UNITED STATES PATENT AND TRADEMARK OFFICE

10/596,664

Office Action Summary	Application No. 10/596,664	Applicant(s) GEVORGIAN ET AL.	
	Examiner DAVID M. SINCLAIR	Art Unit 2831

DETAILED ACTION

Figure 1: Altered version of Maeda '832 fig. 25 showing examiner labels

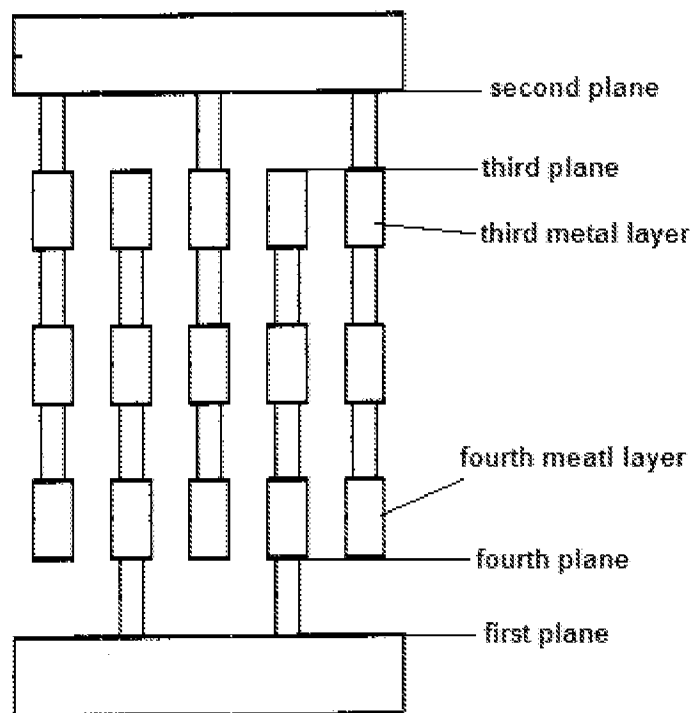
A method of arranging an on-chip capacitor on a chip to create a capacitance between a first conducting connection point (7b – fig. 25; column 8 – line 58 to column 9 – line 6) in a first plane (present office action fig. 1 (POA1)) of the chip and a second conducting connection point (7a – fig. 25; column 8 – line 58 to column 9 – line 6) in a second plane (POA1) of the chip, comprising the steps of creating at least one conducting extension of a first type (9 & 3b – fig. 25; column 8 – line 58 to column 9 – line 6) from the first conducting connection point toward the second plane to a third plane (POA1), and creating at least one conducting extension of a second type (6 & 3a – fig. 25; column 8 – line 58 to column 9 – line 6) from the second conducting connection point toward the first plane to a fourth plane (POA1), wherein the fourth plane is located between the first plane and the second plane, the third plane is located between the fourth plane and the second plane (POA1), and the conducting extension of the first type is isolated from the conducting extension of the second type by a dielectric (2 – fig. 25; column 8 – line 58 to column 9 – line 6) allowing an electric field to be created between the conducting extensions.

The method of claim 30, wherein the first plane is a side of a first metal layer, the second plane is a side of a second metal layer, and the first and second metal layers are different metal layers (column 8 – line 19; POA1).

The method of claim 33, wherein the third plane is a side of a third metal layer, the fourth plane is a side of a fourth metal layer, and the third and fourth metal layers are different metal layers (POA1).

The method of claim 30, wherein the at least one conducting extension of the first type originates in a metal layer and terminates in a metal layer (POA1).

The method of claim 36, wherein the at least one conducting extension of the first type extends through at least one further metal layer (POA1).

The method of claim 30, wherein the at least one conducting extension of the second type originates in a metal layer and terminates in a metal layer (POA1).

The method of claim 38, wherein the at least one conducting extension of the second type extends through at least one further metal layer (POA1).

An on-chip capacitor with a capacitance between a first conducting connection point (7b – fig. 25; column 8 – line 58 to column 9 – line 6) in a first plane (present office action fig. 1 (POA1)) of the chip and a second conducting connection point (7a – fig. 25; column 8 – line 58 to column 9 – line 6) in a second plane (POA1) of the chip, the on-chip capacitor comprising: at least one conducting extension of a first type (9 & 3b – fig. 25; column 8 – line 58 to column 9 – line 6) from the first conducting connection point toward the second plane to a third plane (POA1), and at least one conducting extension of a second type (6 & 3a – fig. 25; column 8 – line 58 to column 9 – line 6) from the second conducting connection point toward the first plane to a fourth plane (POA1), wherein the fourth plane is located between the first plane and the second plane, the third plane is located between the fourth plane and the second plane (POA1), and the conducting extension of the first type is isolated from the conducting extension of the second type by a dielectric (2 – fig. 25; column 8 – line 58 to column 9 – line 6) allowing an electric field to be created between the conducting extensions.

The on-chip capacitor of claim 44, wherein the first plane is a side of a first metal layer, the second plane is a side of a second metal layer, and the first and second metal layers are different metal layers (column 8 – line 19; POA1).

The on-chip capacitor of claim 47, wherein the third plane is a side of a third metal layer, the fourth plane is a side of a fourth metal layer, and the third and the fourth metal layers are different metal layers (POA1).

The on-chip capacitor of claim 44, wherein the at least one conducting extension of the first type originates in a metal layer and terminates in a metal layer (POA1).

The on-chip capacitor of claim 50, wherein the at least one conducting extension of the first type extends through at least one further metal layer (POA1).

The on-chip capacitor of claim 44, wherein the at least one conducting extension of the second type originates in a metal layer and terminates in a metal layer (POA1).

The on-chip capacitor of claim 52, wherein the at least one conducting extension of the second type extends through at least one further metal layer (POA1).

Figure 2: Altered version of Maeda '832 fig. 21 with examiner labels

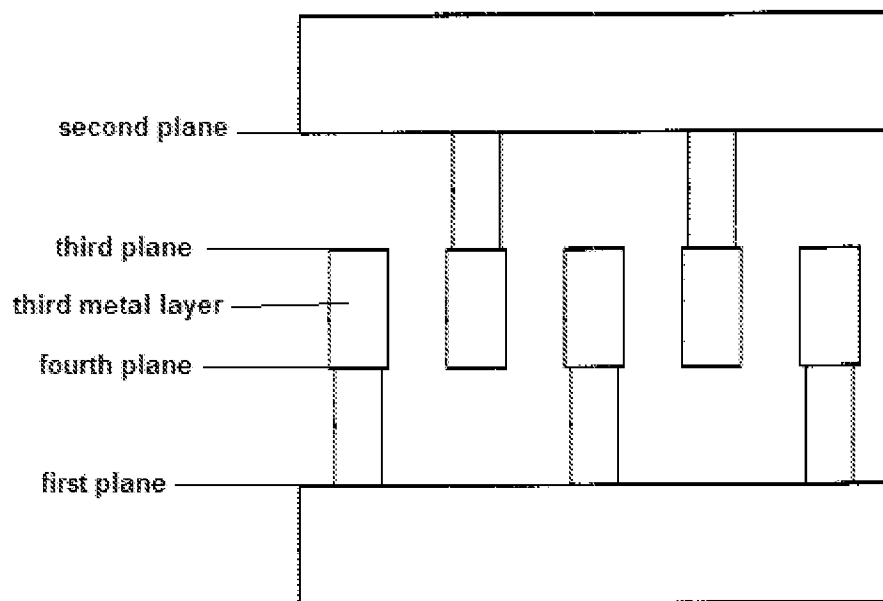
The method of claim 33, wherein the third and fourth planes are different sides of a third metal layer (POA2).

The on-chip capacitor of claim 47, wherein the third and fourth planes are different sides of a third metal layer (POA2).
